STAFF REPORT
Conditional Use, Variance & Site Plan Review (Type III)

SUBJECT PROPERTY: South Wasson Street (25-13-20BB – 9200)
Lots 14-17, Block 33, First Addition to Empire

SUBJECT: **CONDITIONAL USE, VARIANCE & SITE PLAN REVIEW #187-18-065**
Construct a nine (9) unit apartment complex in the Commercial zoning District.

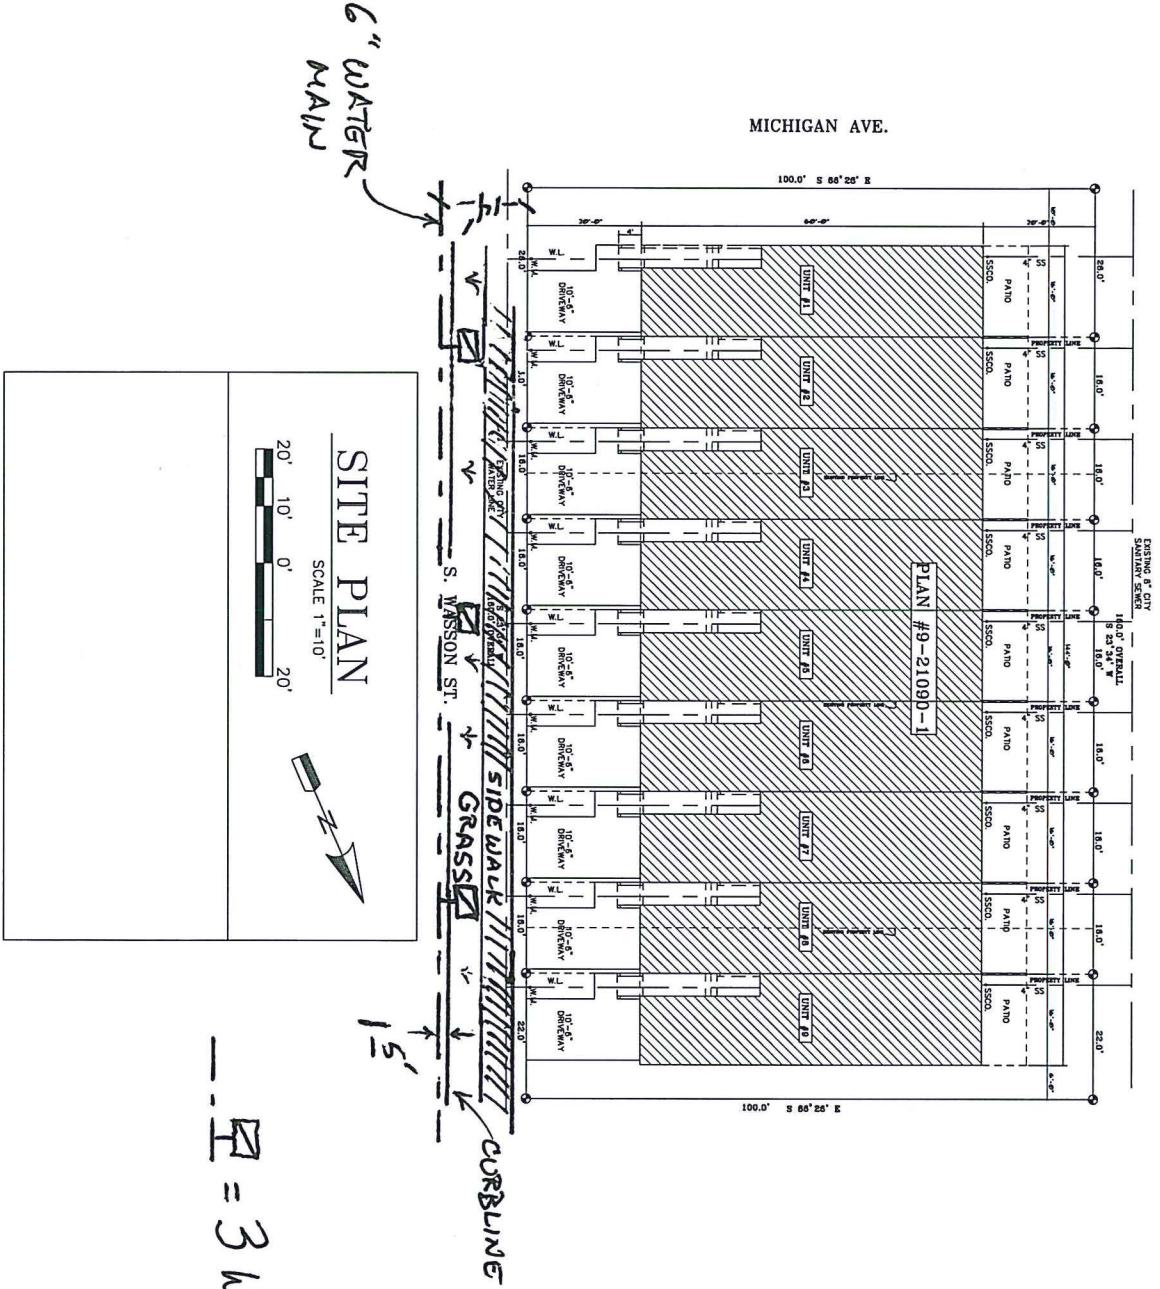
I have added a sketch to your site plan showing our proposed configuration for serving the property. The sketch shows three banks of 3 water meters located between the curb and sidewalk on South Wasson.

Please contact customer service to request water service for the nine houses. This will start the process for getting the services installed. Jeff Page and I are available to answer any questions you may have regarding payment for or configuration of the services.
